TP180076 AND TP181310 "T" LEVER

APPARATUS AFFECTED: 33A-1 to 33A-5, 33C-1 to 33C-5, 33D-1 to 33D-5, and 33F-1 to 33F-5 Teletypewriter-Sets.

OBJECT: To eliminate possible locking of the keyboard if the control or shift keylevers are only partially depressed and prevent possible dislodgment of the break contact wires during keyboard operation.

Figure 1

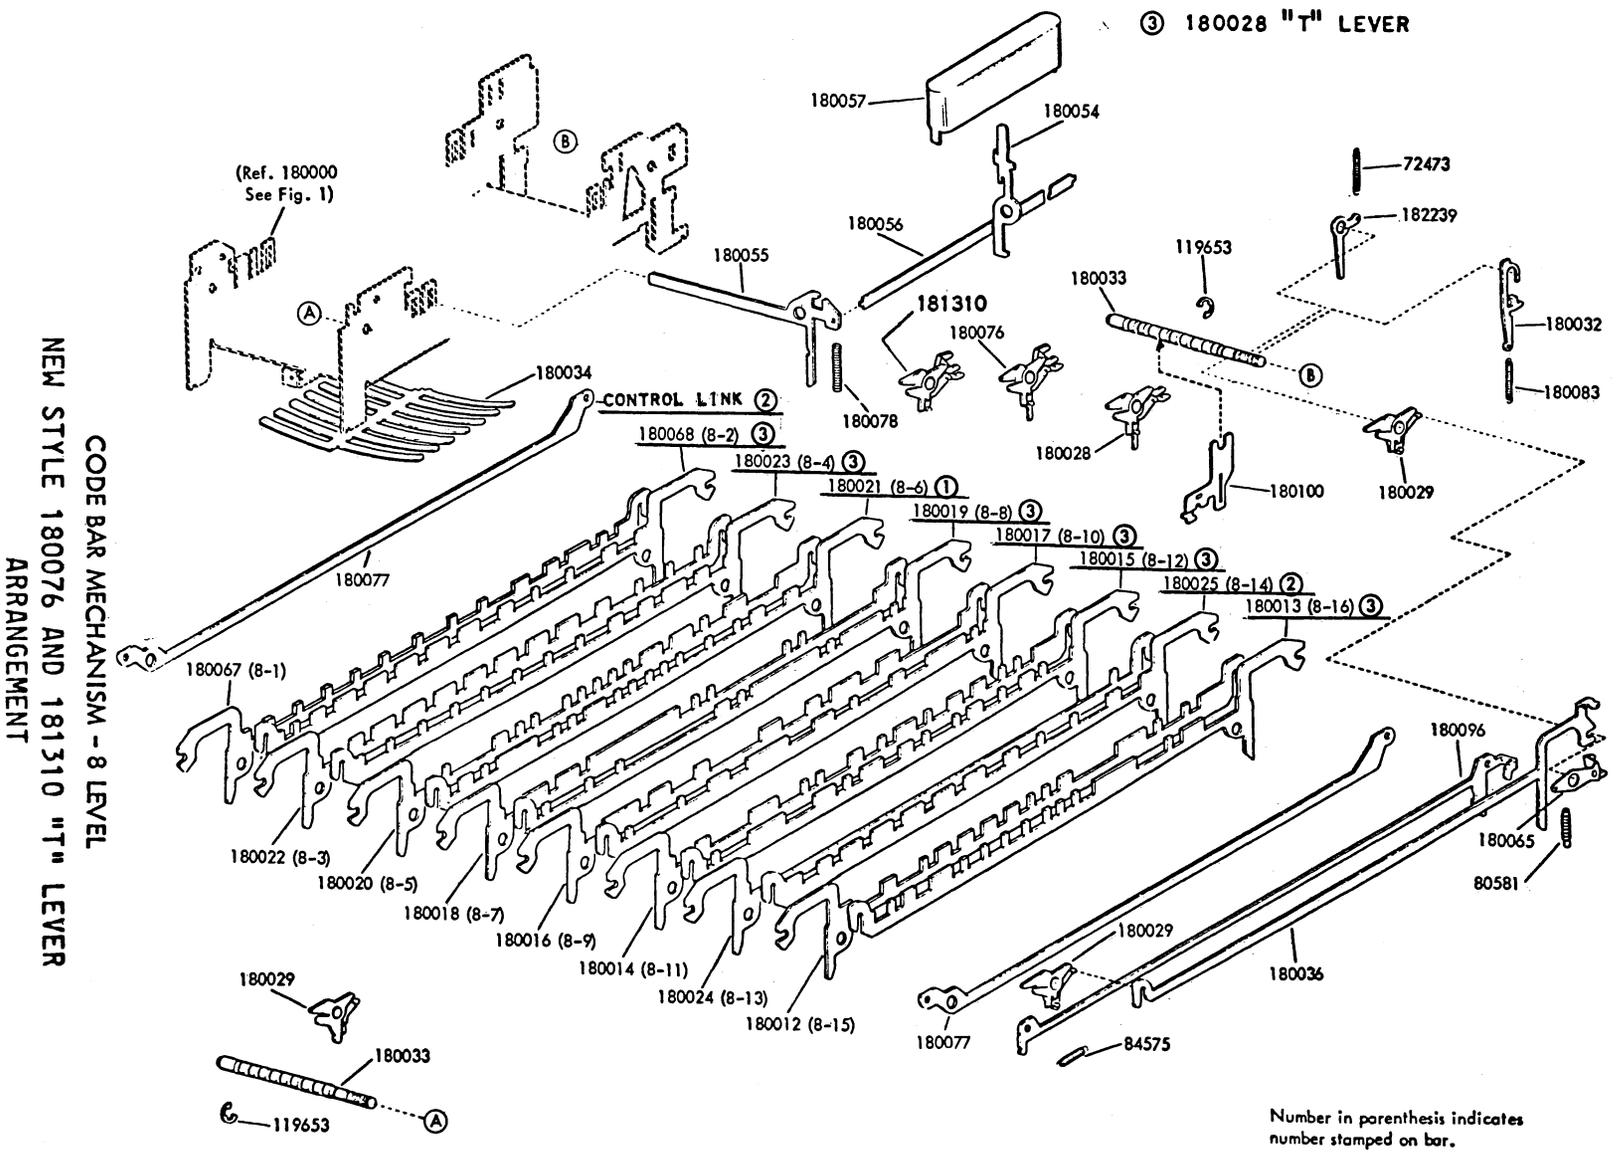
CHANGE: The TP180076 "T" lever associated with the No. 5 contact wires has been modified by

1. lengthening the center extension member of the 3 extensions that guide the contact wires from approximately 53/64 inch to approximately 57/64 inch.
2. adding a 1/16-inch diameter by 5/64-inch long projection at a right angle to the tip of the lengthened center extension.

A TP181310 "T" lever replaces the old style TP180076 "T" lever associated with the shift code bar and control tie bar.

IDENTIFICATION: The 3 extensions on the old style TP180076 "T" lever are identical. The center extension on the new style TP180076 "T" lever is longer and has a projection.

New style TP181310 "T" levers resemble new style TP180076 "T" levers but the lower blocking extension below the code bar support bearing post section has been omitted.
